## **RABBIT CREEK COMMUNITY COUNCIL (RCCC)**

June 10, 2022

### **Re: Revised COMMENTS: TRACT A RIVER HILLS ESTATES/TARAS SUBDIVISION S-12671**

Groundwater Photo Survey  
Location Key

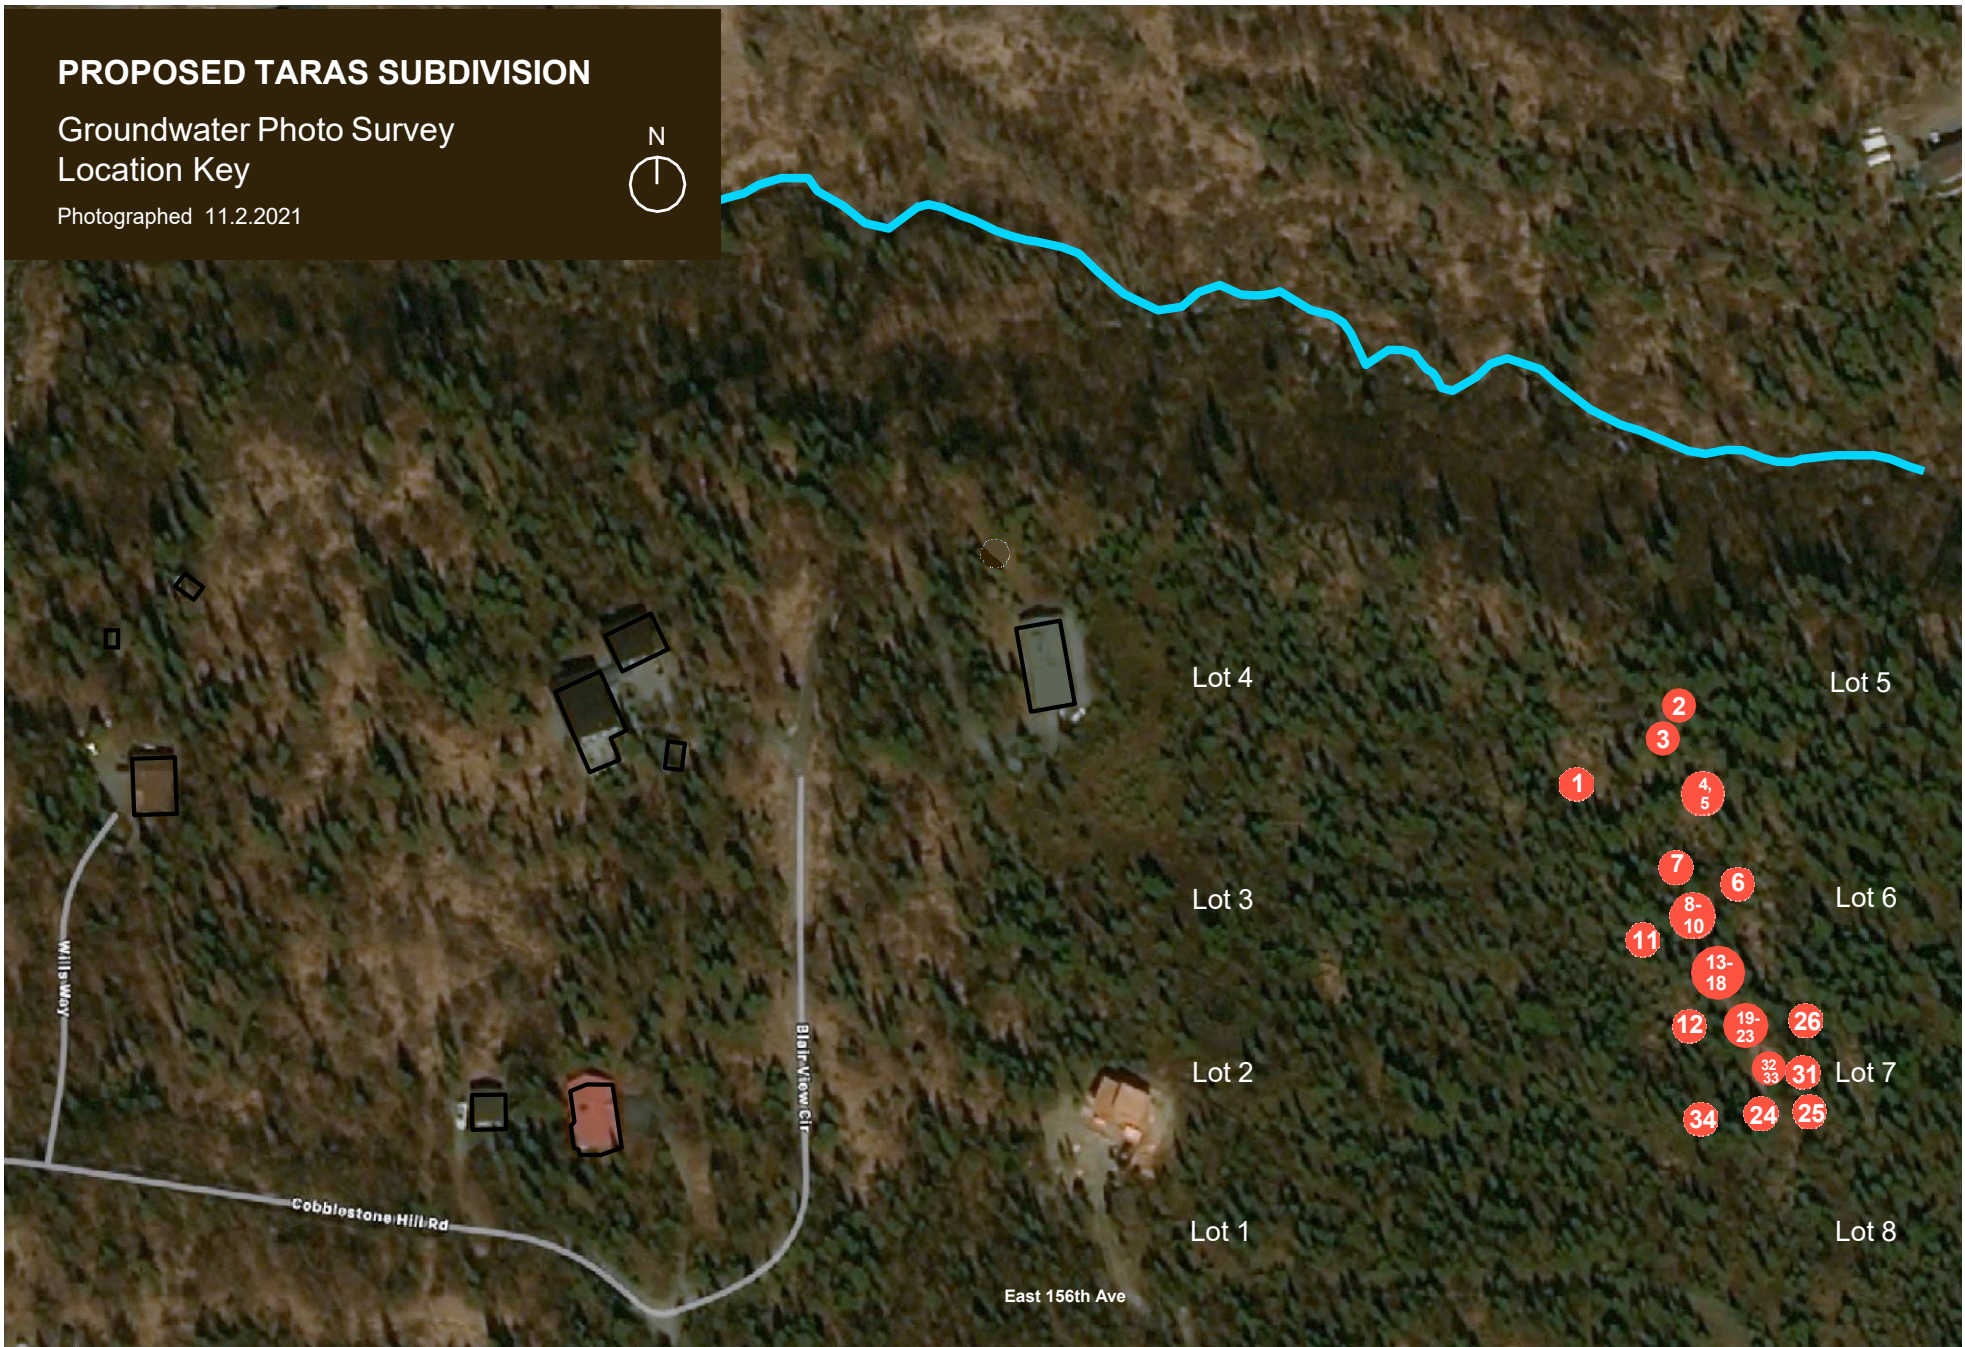
3. Wetlands and drainage.
  - A. A wetlands and hydrology study should be completed before final approval of the plat. Long-time residents have observed standing water on the Taras tract, especially during spring and fall. This appears to be documented by photos from the developer's groundwater field survey in November 2021 (see attached). The Taras tract appears to be the catchment area for several large undeveloped tracts

lying upslope to the east and southeast (e.g., Mountain Air Estates and Spruce Terraces). As those upslope tracts are developed, they will create more rapid run-off that may discharge to, or flow through, the Taras parcel.
